Lee Nuclear Station Units 1 and 2

Evaluation of 2012 Field Investigation Results for Plant Relocation

FIGURE 17

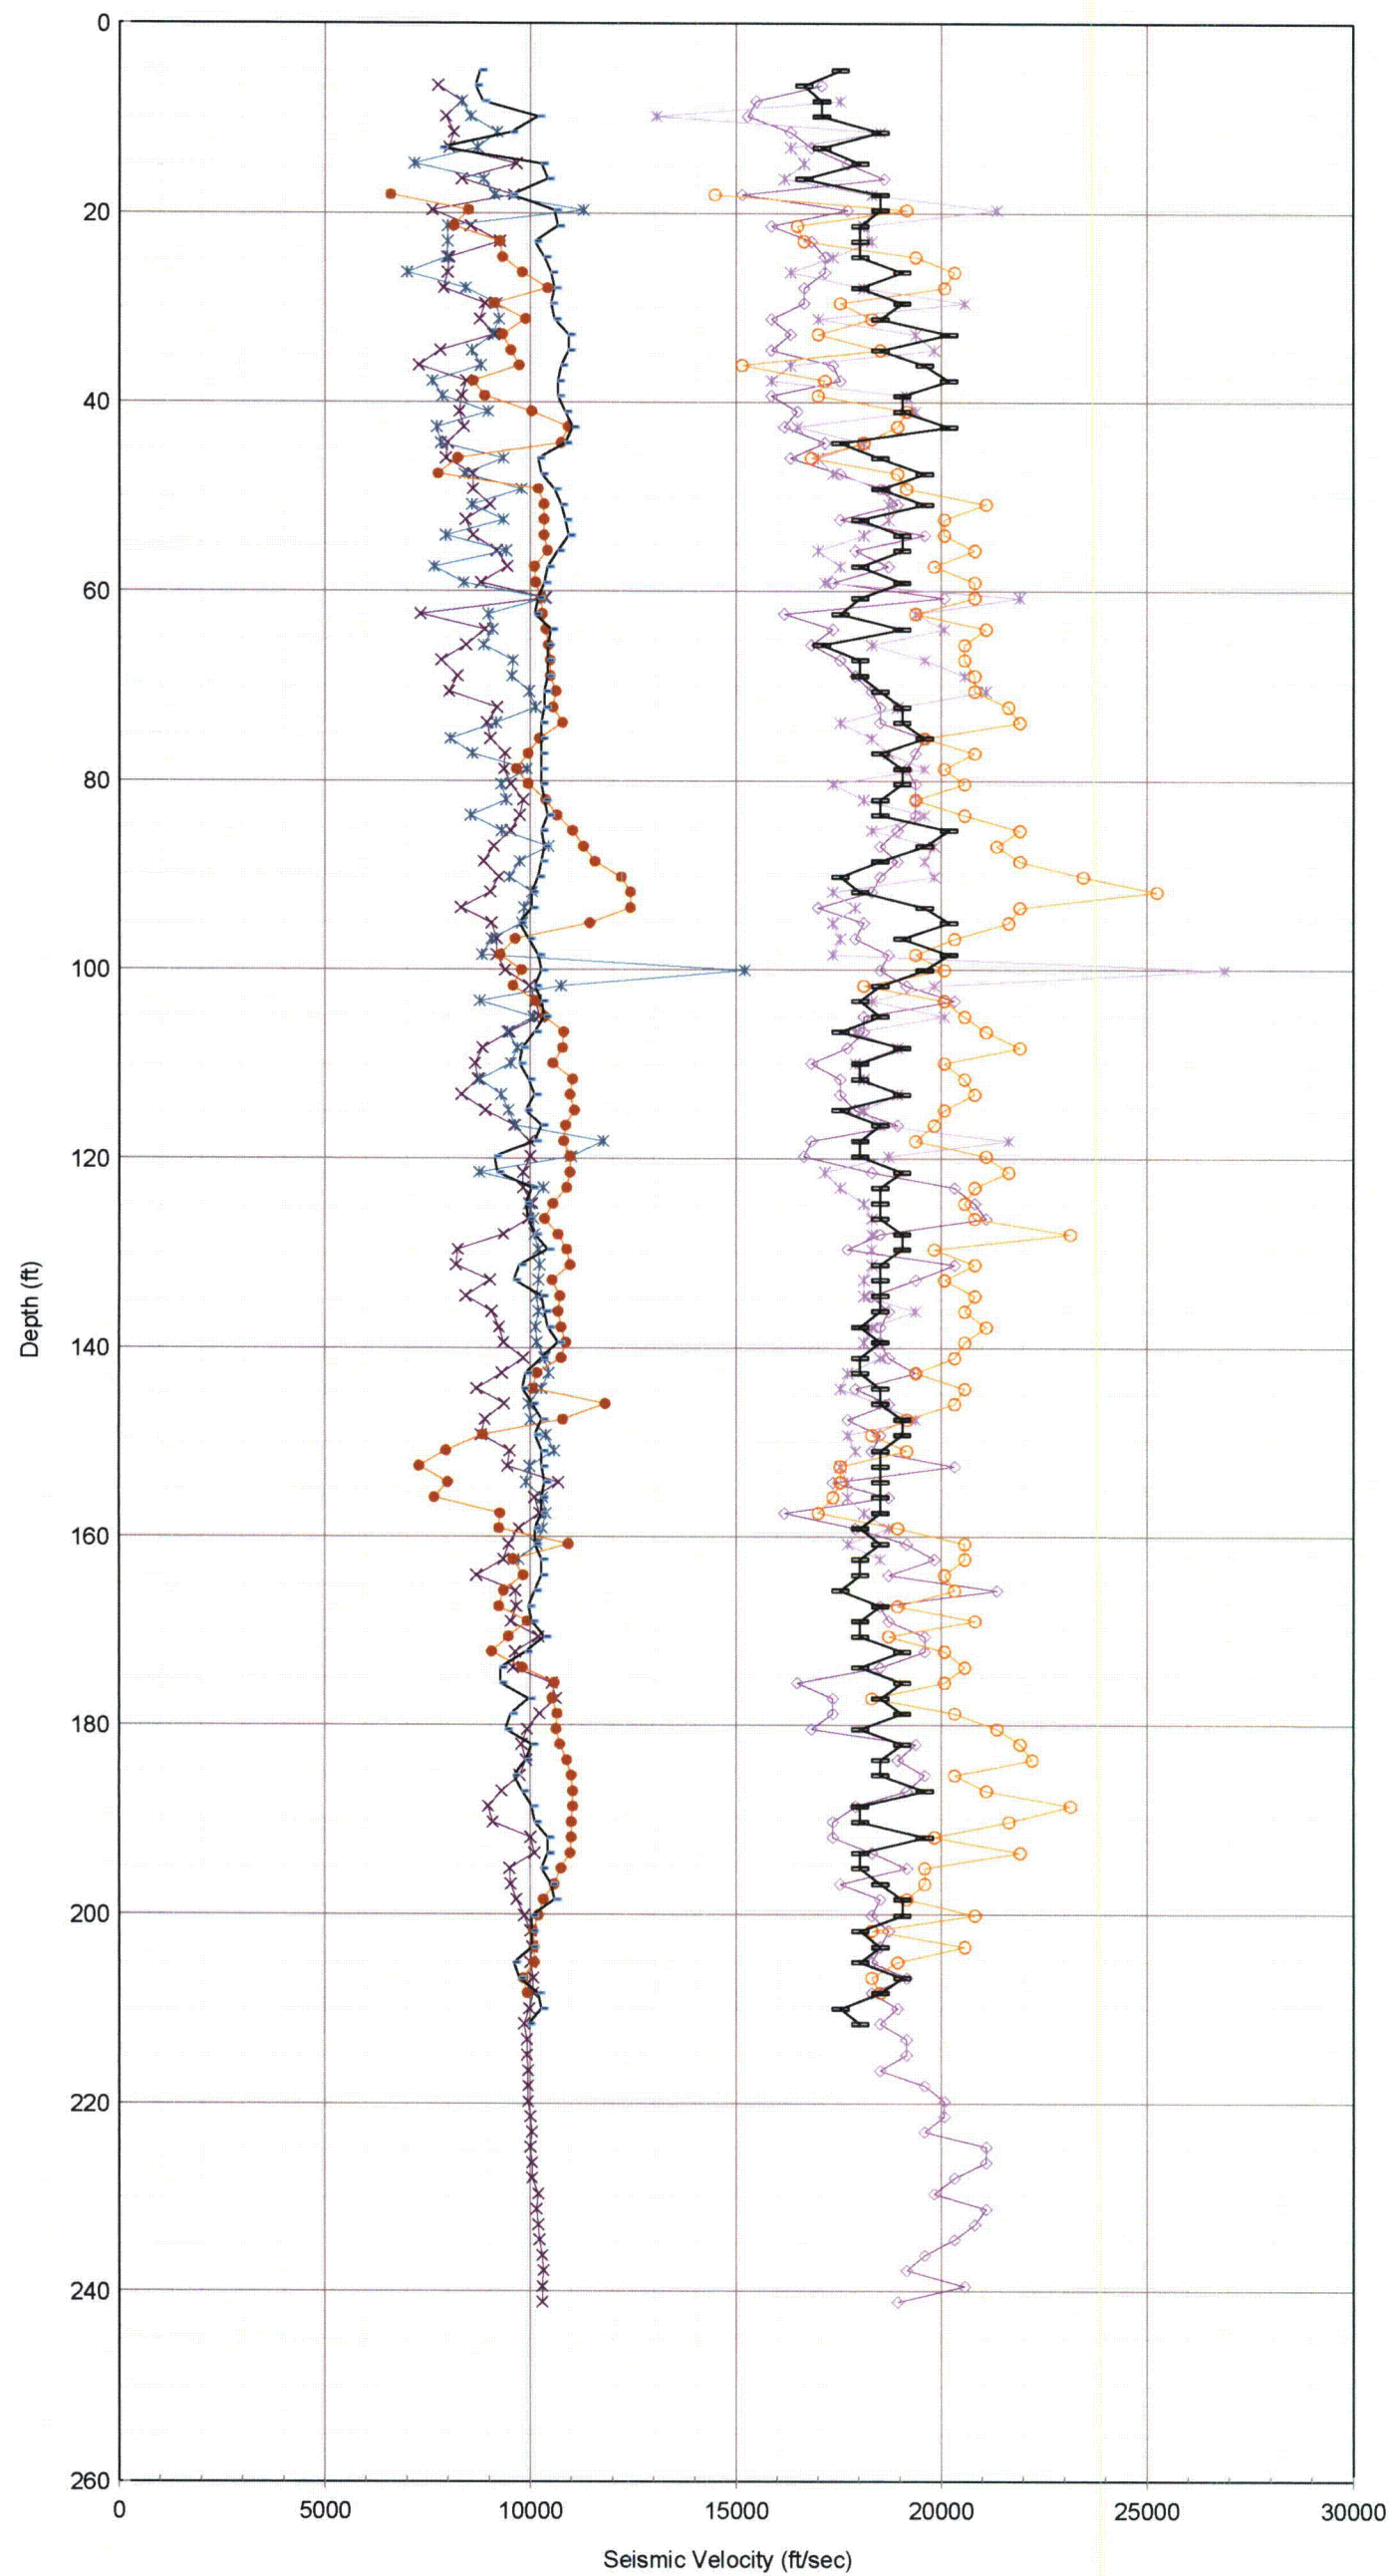
In Figure 17, the seismic wave velocities from P-S Suspension data for the relocated Unit 1 nuclear island 2012 borings B-2000 and B-2002 is compared to the results from 2006-2007 logs. Inspection of this figure shows the 2012 shear wave (V_s) and compression wave (V_p) data are consistent with previous results and show good correlation to the COLA data in FSAR Revision 6.

The comparisons described above show that the V_s and V_p data at WLS Unit 1 from the 2012 borings is consistent with the 2006-2007 borings; thus the dynamic profile (Base Case A1 – Unit 1, FSAR Figure 2.5.4-252 Rev. 6) for the Unit 1 relocated nuclear island is valid for the relocated plant. Note that the revised FIRS A1 – Unit 1 dynamic profile has 3 ft. thickness of fill concrete added to the top of the profile due to the raised plant elevation and is shown in Figure 19. The local velocity profile B (FSAR Figure 2.5.4-249 Rev. 6) at the northwest corner of WLS Unit 1, before relocation, does not exist at the northwest corner of the relocated WLS Unit 1 and therefore is not considered as part of this evaluation.

WILLIAM STATES LEE III
NUCLEAR STATION UNITS 1 & 2
Schematic Comparison of August 2012
to Pre-August 2012 Dynamic Profile -
Base Case A1 at Unit 1 Nuclear Island
FIGURE 19

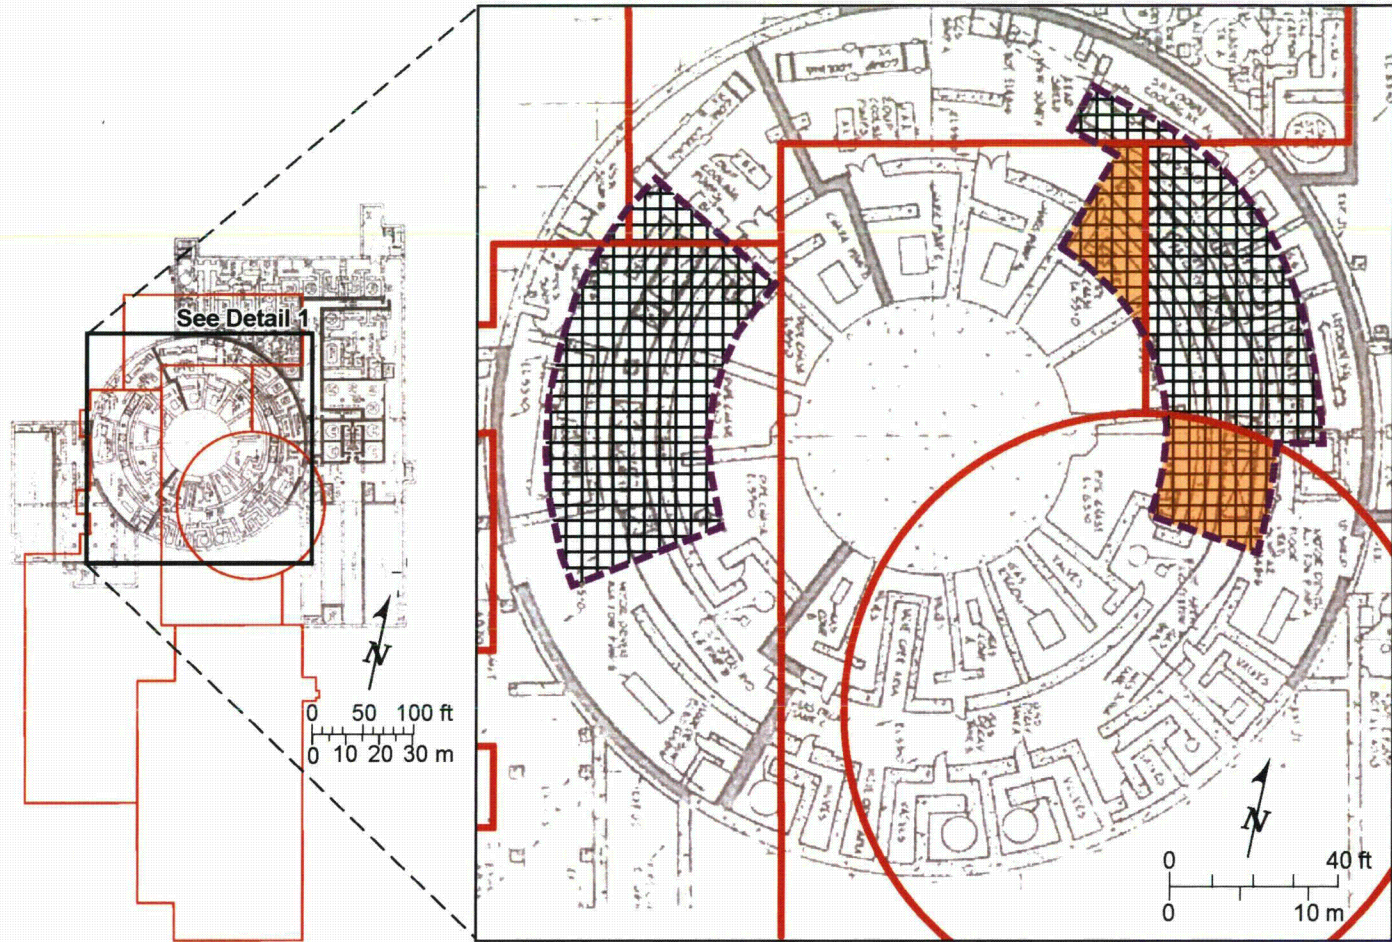
Suspension results to COLA (FSAR Revision 6) testing results. Figure 19 illustrates the small increase in concrete fill thickness for the 2012 to pre-2012 Dynamic Profile - Base Case A1.

Change in the shear wave velocity profile attributed to the increased concrete fill thickness (3 ft.) at the hard rock condition results in a negligible variation in site response calculations for relocated Unit 1. The additional thickness of fill concrete amounts to a 15% increase in the fill concrete profile for relocated FIRS A1 for the relocated Lee Nuclear Station Unit 1 nuclear island. The average shear wave velocity of the shear wave velocity profile with the added concrete is slightly different from the average shear wave velocity of the profile before the addition of the 3 ft. of fill concrete. This small change will have no practical significance on differential shear wave velocity, site amplification or foundation performance and compliance with the subsurface uniformity criteria as described in AP1000 DCD Subsection 2.5.4.5.

FIGURE 20

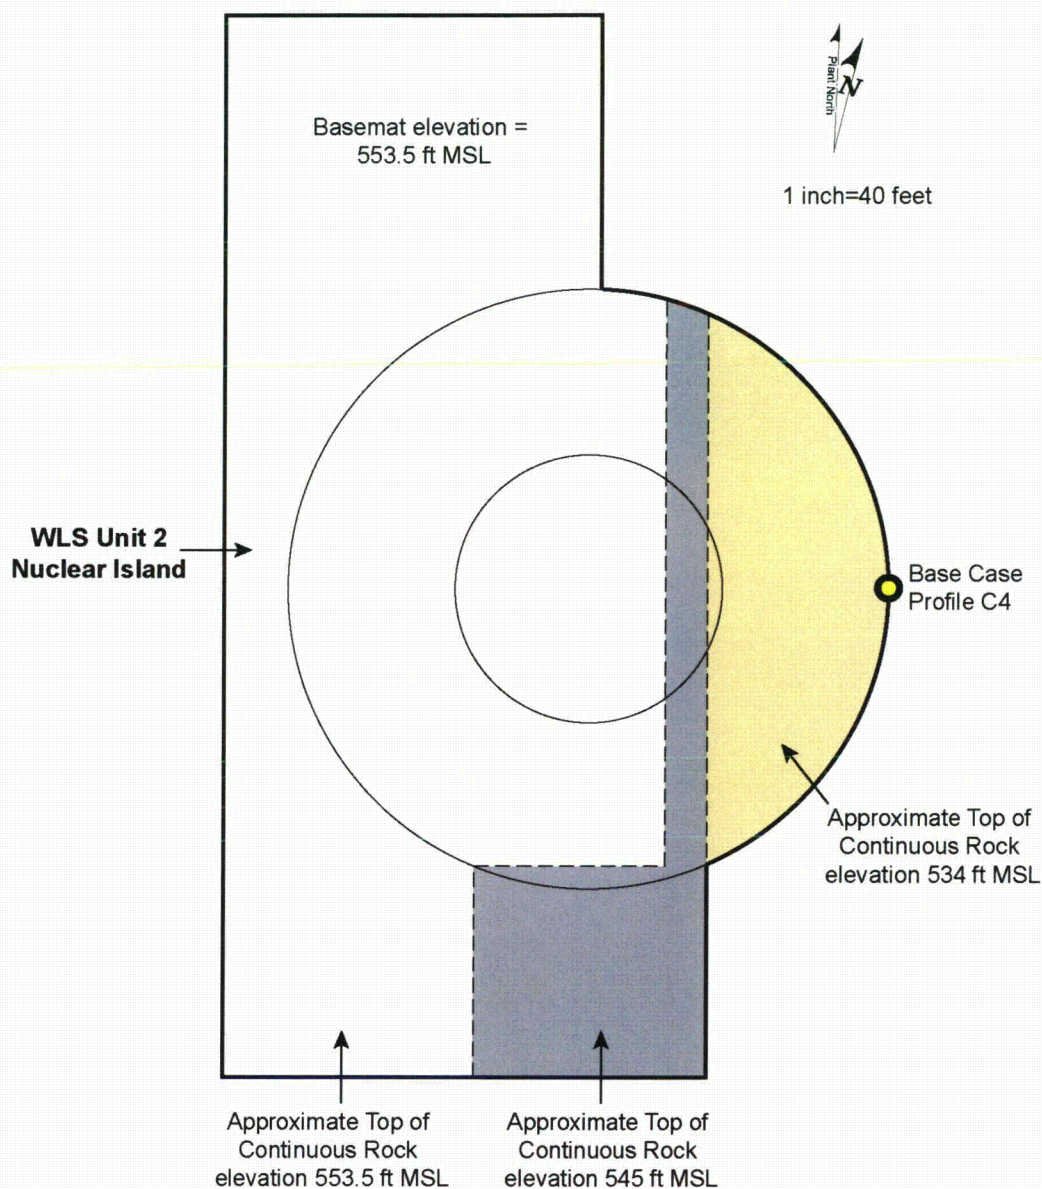
As illustrated in Figure 20, the conditions associated with FIRS A5 are only applicable to a small localized portion of the Unit 1 footprint, while FIRS A1 is applicable to the remainder. Since the nuclear island basemat will respond as a unit, the actual input to the nuclear island will be much closer to FIRS A1, and the contribution of FIRS A5 will not adversely impact the overall response of Unit 1. Similarly, FIRS C4 was developed as a sensitivity analysis of the potential effects of localized fill concrete beneath the eastern extents of Unit 2. The potential effects of

2012. This subsection will include a discussion regarding the existing Cherokee Nuclear Station concrete foundation that has several local pits (referred to as pump rooms) that were to serve various purposes (Figure 20). These local pits were typically to be provided with horizontal and vertical waterproofing membranes. In pits having the horizontal and vertical waterproofing membranes, these features will be removed down to the top of the fill concrete layer resting on the continuous rock and outward to the surrounding rock and replaced with new fill concrete.

FIGURE 21

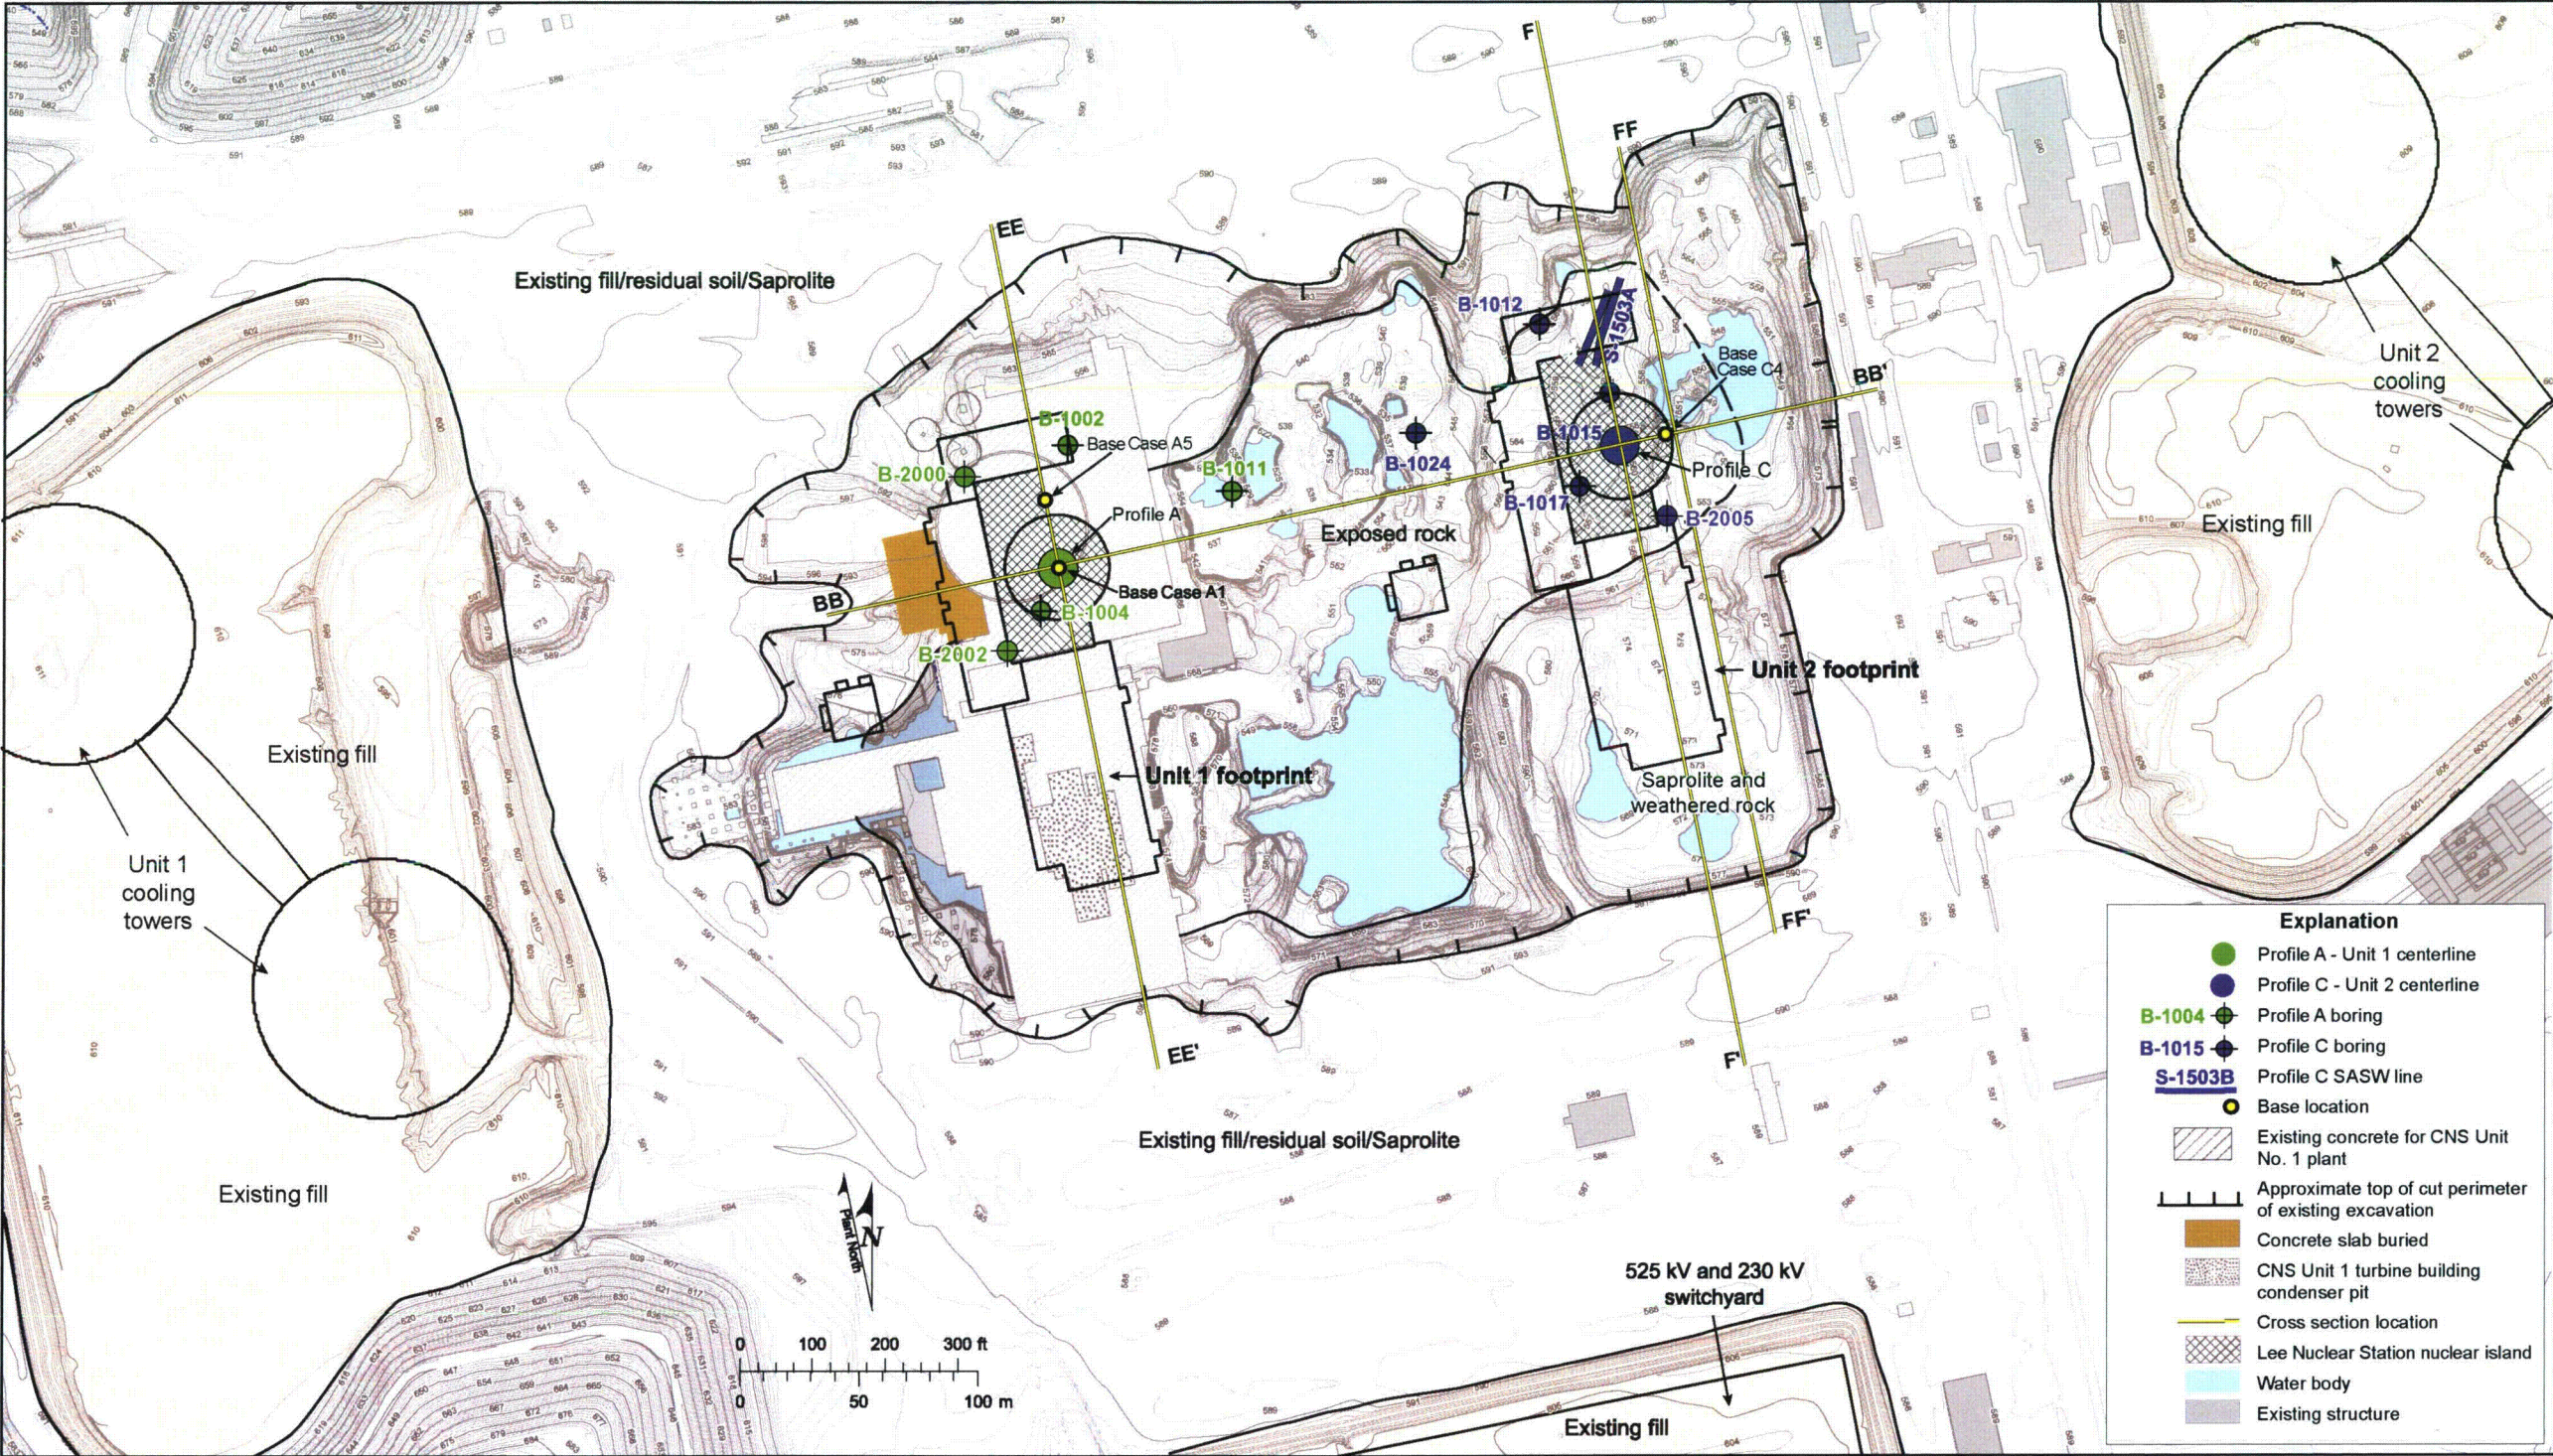
FSAR Subsection 2.5.4.5.2.2 – Unit 2 Excavation Conditions, will be revised to note that the eastern edge of the relocated nuclear island will require about 20 ft. of fill concrete between the bottom of the nuclear island and the top of continuous rock (Figure 21). The central and western portions of the relocated WLS Unit 2 nuclear island will require only minimal thicknesses of fill concrete.

This subsection will be revised to reflect the maximum thickness of fill concrete is about 16 to 20 feet beneath the east portion of the nuclear island, but generally will be less than about 1 to 2 feet as depicted in Figures 16 and 21 (new FSAR Figures 2.5.4-264 and 2.5.4-267). This relatively small area of concrete fill required to build up the eastern edge of the Unit 2 nuclear island basemat will not result in localized adverse conditions due to the relatively small difference in shear wave velocity of fill concrete (7,500 ft/sec) and rock (8391 to 8983 ft/sec) in this area. The fill concrete conditions described for the Lee Nuclear Station Unit 2 nuclear island eastern portion have no practical significance on differential shear wave velocity, site amplification or foundation performance.

- For relocated Unit 2, the eastern edge of the relocated nuclear island foundation will be supported on about 20 ft. of fill concrete between the bottom of the nuclear island and the top of continuous rock (Figure 21). This relatively small localized area of concrete fill underlying the eastern edge of the relocated Unit 2 nuclear island will not result in localized amplification / deamplification effects due to the relatively small difference in the average shear wave velocities for fill concrete (7,500 ft./sec.) and surface rock (8,391 ft./sec. to about 8,983 ft./sec.) in this area (FSAR Figure 2.5.4-250). The addition
